Item Name: Crosstube Turning Detail

DART AEROSPACE LTD	Work Order:	95446
Description: Crosstube Assembly (206B High Fwd)	Part Number:	D206-667-141
Inspection Dwg: D206-667-141 Rev: C		Page 1 of 2

DRAWING NO. D206-667-141	TITLE CROSSTUBE ASS'Y (206B HIGH FWD)	REV. C	DART AEROSPACE LTD ENGINEERING ORDER		D.E.O. NO. D206-667-141-C-1	SHEET NO. SHEET 1 OF 1	SCALE NTS
DRAWN <i>q</i>	CHECKED <i>ASS</i>	MFG. APPR. <i>JD</i>	APPROVED <i>WD</i>		DE APPR. <i>HA</i>		
DATE 11.07.15	DATE 11.07.20	DATE 11.07.21	DATE 11/07/21		DATE 11.07.21

DRAWING NO. D206-667-141		TITLE CROSSTUBE ASS'Y (206B HIGH FWD)		REV. C DART AEROSPACE LTD ENGINEERING ORDER		D.E.O. NO. D206-667-141-C-2		SHEET NO. SHEET 1 OF 1		SCALE NTS	
DRAWN AJS		CHECKED		MFG. APPR. <i>E</i>		APPROVED <i>AP</i>		DE APPR. <i>AP</i>			
DATE 12.08.02		DATE 12.08.02		DATE 12.08.02		DATE 12.08.02		DATE 12.08.02

DETAIL P
BONDING STRAP INSTALLATION 2 PL

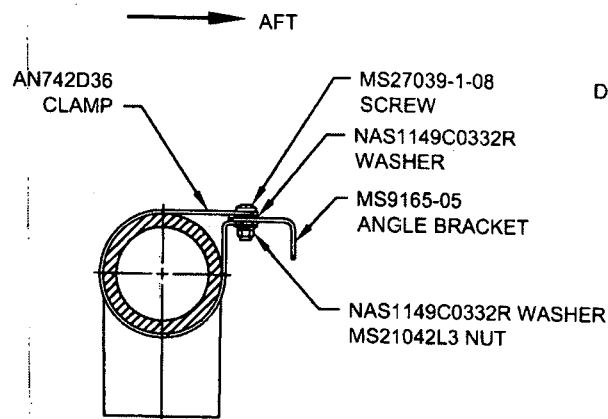
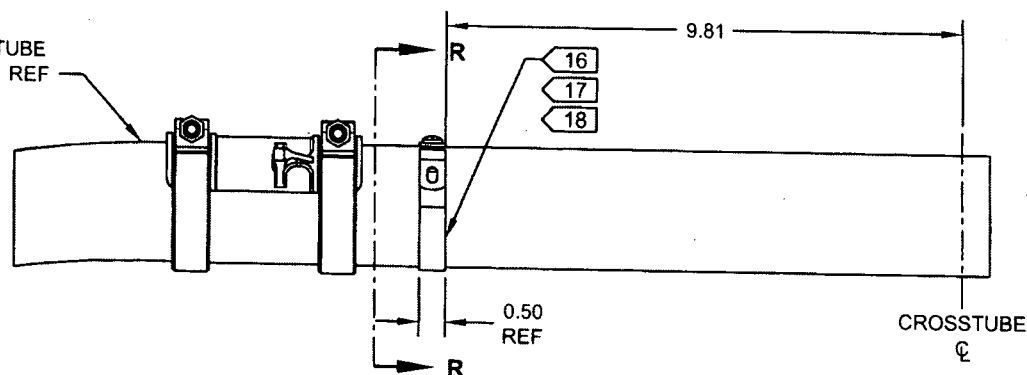
ADD ELECTRICAL GROUNDING STRAP

ITEM	QTY -141	PART NUMBER	DESCRIPTION
1	X	D206-667-141	CROSSTUBE ASSEMBLY (206B HIGH FWD)
10	2	AN742D36	CLAMP
11	2	MS9165-05	ANGLE BRACKET
12	2	MS21042L3	NUT (OR MS21042-3)
13	2	MS27039-1-08	SCREW
14	4	NAS1149C0332R	WASHER (OR AN960C10L)

- 16) MASK AREA UNDER CLAMP PRIOR TO PAINTING
- 17) SEAL EDGES WHERE AN742D36 CLAMP MEETS WITH THE CROSSTUBE USING SIKAFLEX-241/-291 OR MIL-S-8802 CLASS B2 OR PROSEAL 890 SEALANT
- 18) PERFORM RESISTANCE CHECK TO ENSURE MAX RESISTANCE IS 10 MILLIOHMS
